CITY OF SEGUIN &
GUADALUPE COUNTY

30% SUBMITTAL

FEDERAL AID PROJECT
PROJECT NO.
CSJ: 0915-46-052
LIMITS FROM: SH 46
TO: SH 123

FOR WORK CONSISTING OF EXPANDING ROADWAY FROM 2 TO 4 LANES WITH RAISED MEDIAN OR CENTER TURN LANE. REALIGN CORDOVA ROAD AT SH 46. ADD SHARED USE PATHS.

SHEET 3 OF 44

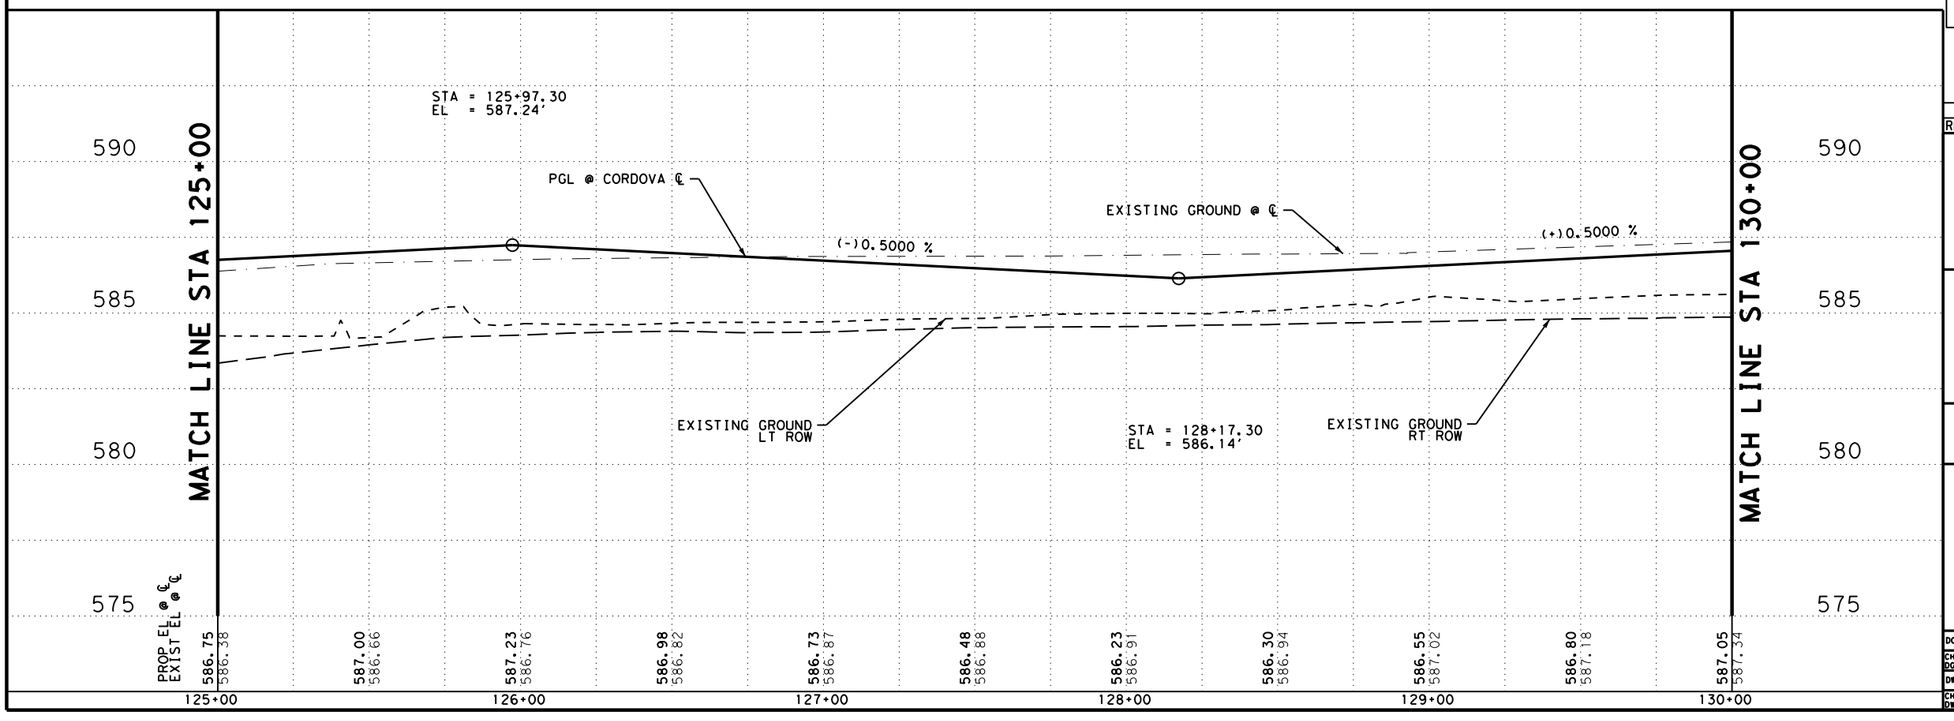
Drainage flowline arrows?

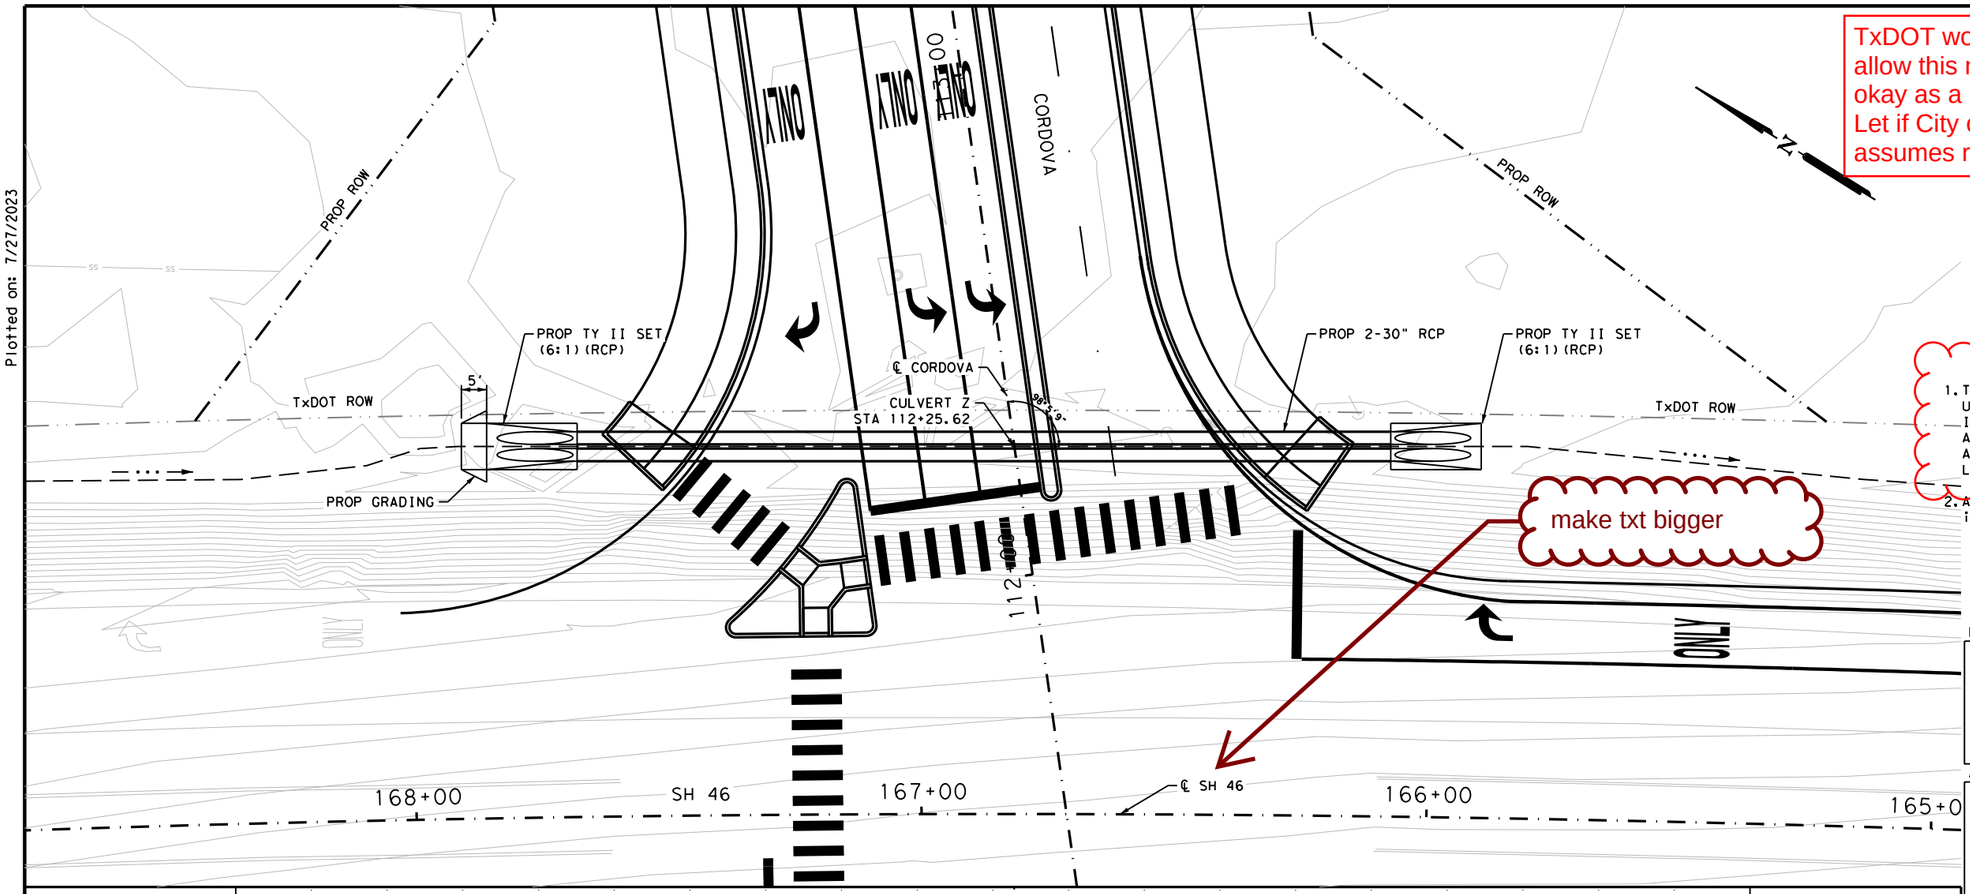
TxDOT would not allow this note. Is it okay as a Local Govt Let if City of Seguin assumes risk?
